Product Change Notification

Date Issued :	June 22, 2023	PCN Number :	513927
Reason for Change :	Change to Product		
Description of Change :	This notification is to inform you of the correction of an error in the SD for the part(s) on the attached list. For details, please see below.		
Assessment of Change :	No change to parts - Form/Fit/Function		
Planned Implementation Date :	December 28, 2023		
Sample Availability Date:	June 23, 2023		
Internal Molex Qualification Date :	June 23, 2023		
Last date to request Samples by Customer :	June 23, 2023		
Traceability Code Markings / Date :	No special marking on the product or packaging

Before Picture

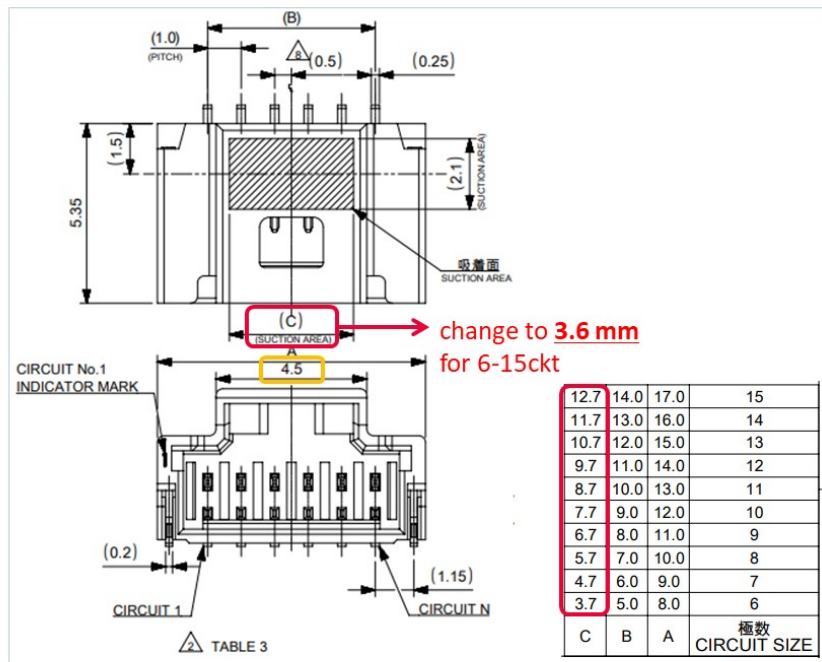
In above drawings, suction area width, indicated as dimension C, should be 3.6 mm due to 4.5 mm the hood width.

This is only applied to 6-15ckt, inner lock type header.
